Final Environmental Statement

related to the operation of
Braidwood Station,
Units 1 and 2

Docket Nos. STN 50-456 and STN 50-457

June 1984

Figure 4.1 Location and orientation of principal plant structures
Source: ER-OL Figure 2.1-4

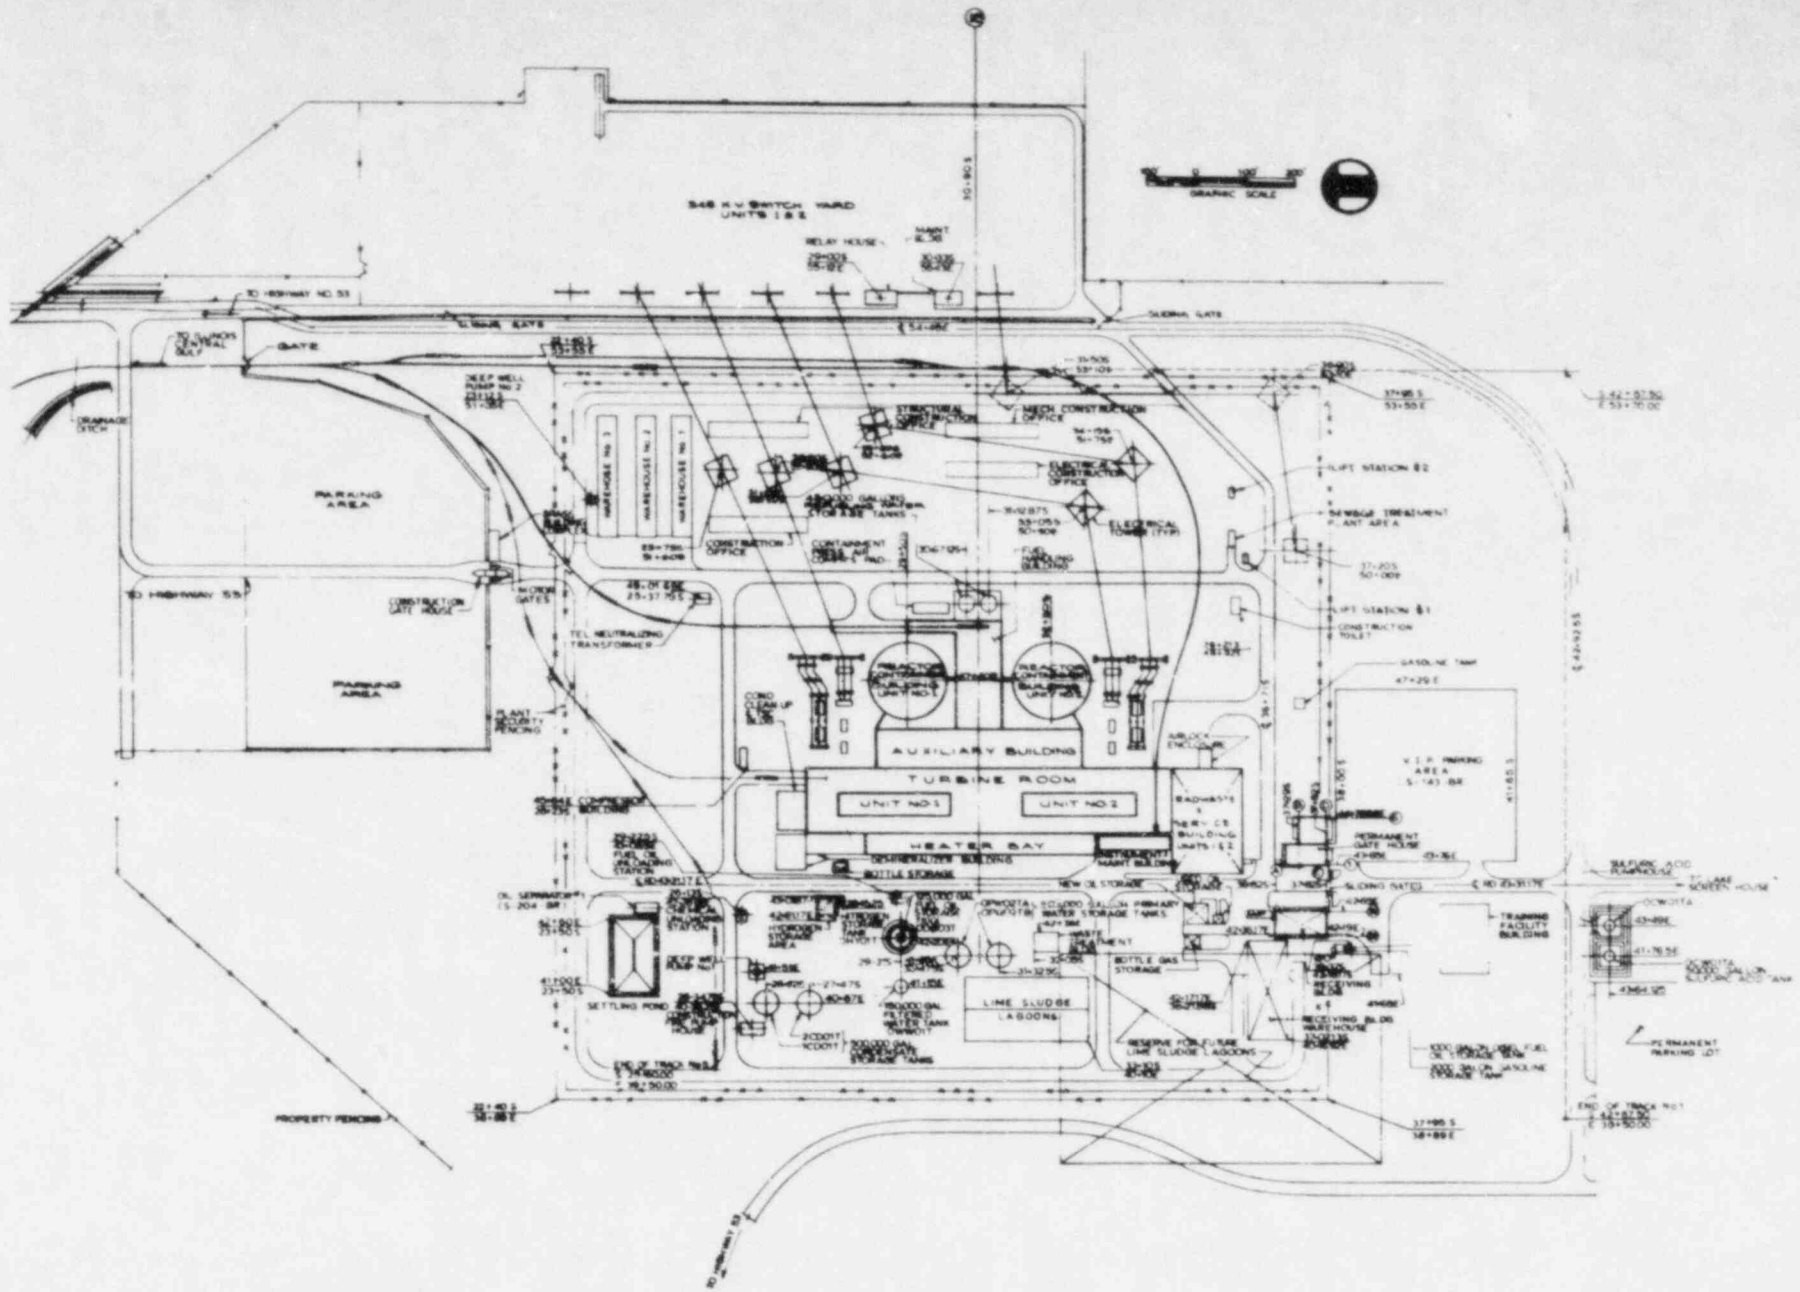
CECo 3: CECO stated that Figure 4.1 has been revised.

Staff Response: The revised figure has been included in the FES (Figure 4.1).

Figure 4.5 Transmission connections
Source: ER-OL Figure 3.9-1

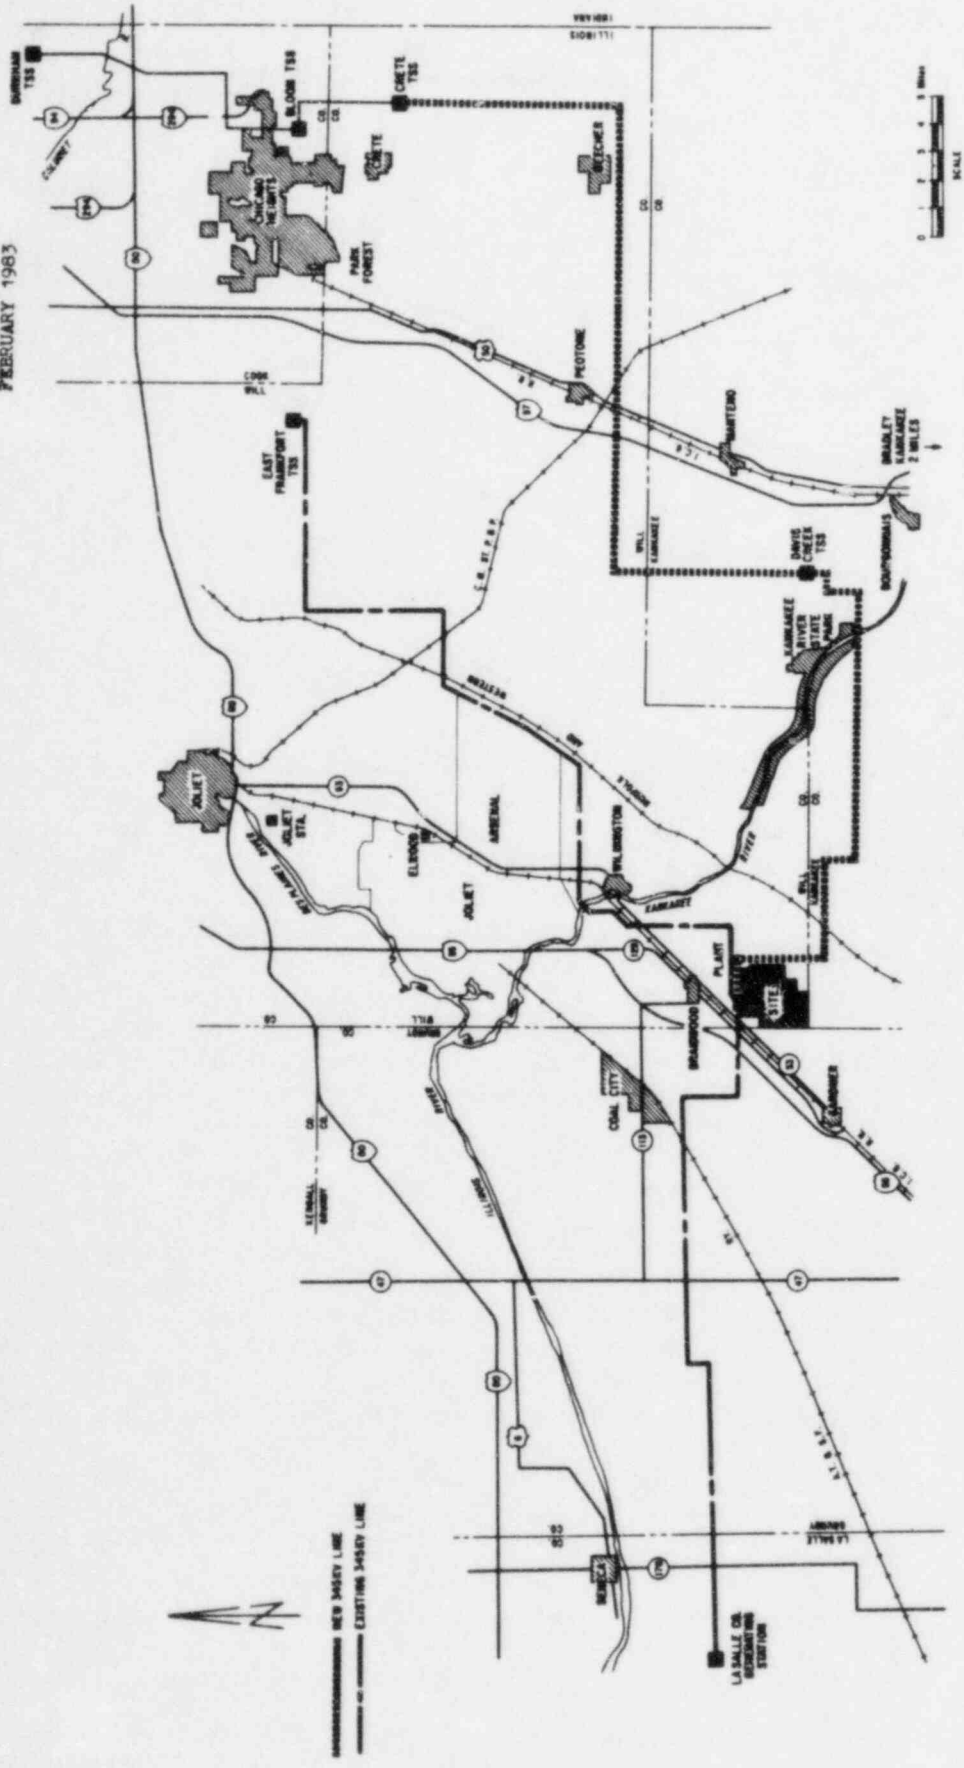
CECo 17: CECo noted that the legend symbol for the new 345-kV lines was incorrect in Figure 4.5.

Staff Response: Figure 4.5 has been revised as suggested by the applicant.
